UNITED STATES PATENT AND TRADEMARK OFFICE

APPLICATION NO.	FILING DATE	FIRST NAMED INVENTOR	ATTORNEY DOCKET NO.	CONFIRMATION NO.
10/728,908	12/08/2003	Toshio Maruyama	A-9993	9304

Office Action Summary	Application No. 10/728,908	Applicant(s) MARUYAMA ET AL.	
	Examiner Katherine W. Mitchell	Art Unit 3677

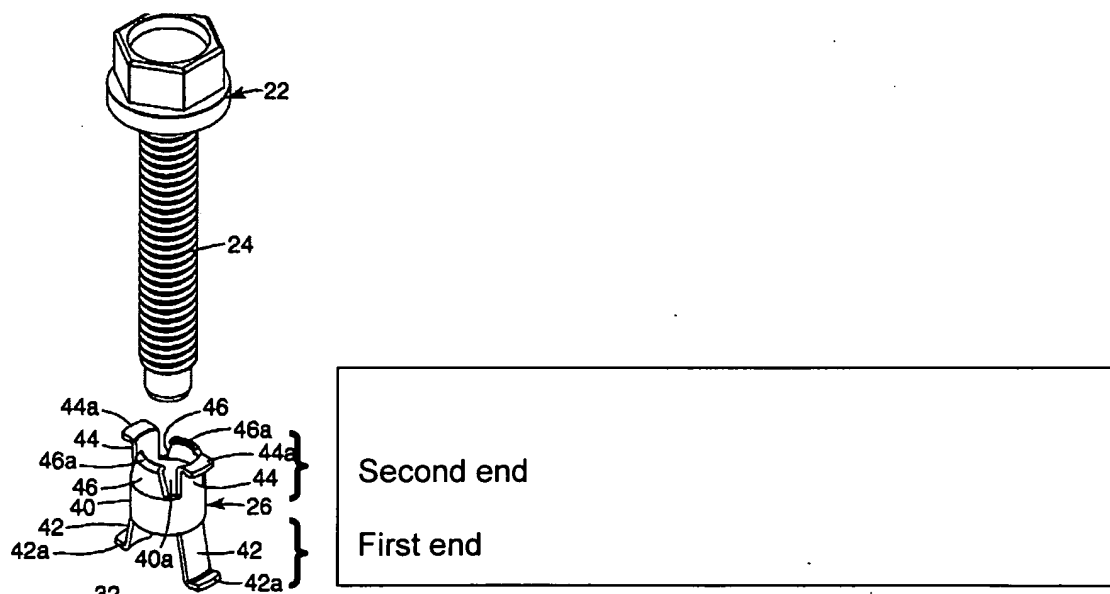
5. Claim 1,3,4 6, are rejected under 35 U.S.C. 102(b) as being anticipated by Rebers et al USP 6174118.

Rebers teaches a fastener adapted to be attached to a sheet-shaped member, so that the sheet-shaped member can be attached to a mounting member via the fastener, the fastener comprising:
a tubular shank (24) adapted to be inserted into a mounting hole of the sheet-shaped member;

shank; a flange (44a) extending outward from a second end of the shank, and {capable of} having an outer cross-dimension greater than an inner cross-dimension of the mounting hole of the sheet-shaped member; and at least one stud-engagement pawl (46a) extending into the interior of the shank, wherein the shank {is capable of} has a length less than that of a stem of a stud fixed to a mounting member with which the fastener is to be engaged, so that the stud stem protrudes from a first surface of the sheet-shaped member after the shank is inserted into the mounting hole, with the holding piece leading, until the holding piece is juxtaposed with the first surface and the flange is juxtaposed with an opposite second surface of the sheet-shaped member, and the stud is passed through the shank and the pawl is engaged with the stud, and wherein protrusion of the stud stem allows an auxiliary member to be mounted thereto (inherently capable of this function – no structure positively recited).

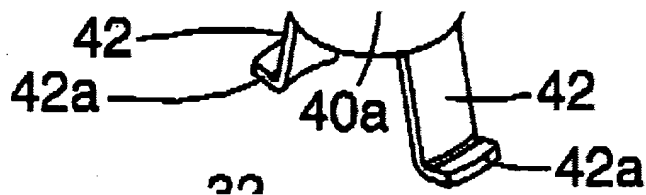
(46a) extending into the interior of the shank, wherein the shank {is capable of} has a length less than that of a stem of a stud fixed to a mounting member with which the fastener is to be engaged, so that the stud stem protrudes from a first surface of the sheet-shaped member after the shank is inserted into the mounting hole, with the holding piece leading, until the holding piece is juxtaposed with the first surface and the flange is juxtaposed with an opposite second surface of the sheet-shaped member, and the stud is passed through the shank and the pawl is engaged with the stud, and wherein protrusion of the stud stem allows an auxiliary member to be mounted thereto (inherently capable of this function – no structure positively recited), wherein there are a plurality of the stud-engagement pawls, (two are shown in the figure) each extending radially inward from a position near the first end of the shank.

Re claim 4: A fastener adapted to be attached to a sheet-shaped member, so that the sheet-shaped member can be attached to a mounting member via the fastener, the fastener comprising: a tubular shank (24) adapted to be inserted into a mounting hole of the sheet-shaped member; at least one holding piece (42a), extending outward from a corresponding partial portion of the periphery of a first end of the shank; a flange (44a) extending outward from a second end of the shank, and {capable of} having an outer cross-dimension greater than an inner cross-dimension of the mounting hole of the sheet-shaped member; and at least one stud-engagement pawl (46a) extending into the interior of the shank, wherein the shank {is capable of} has a length less than that of a stem of a stud fixed to a mounting member with which the fastener is to be

engaged, so that the stud stem protrudes from a first surface of the sheet-shaped member after the shank is inserted into the mounting hole, with the holding piece leading, until the holding piece is juxtaposed with the first surface and the flange is juxtaposed with an opposite second surface of the sheet-shaped member, and the stud is passed through the shank and the pawl is engaged with the stud, and wherein protrusion of the stud stem allows an auxiliary member to be mounted thereto (inherently capable of this function – no structure positively recited), and wherein after an auxiliary member is mounted to the stud stem, a wall of the auxiliary member is in contact with the holding piece and the first end of the shank to allow the wall of the auxiliary member to be located at a position apart from the mounting member by a given distance (inherently capable of this function – no structure positively recited).

Re claim 6. The fastener as defined as defined in claim 1, wherein the holding piece arms (42a) have flat surfaces aligned with the first end of the shank.

42a is clearly shown as having flat

surfaces {capable of} aligned with the first end of the shank
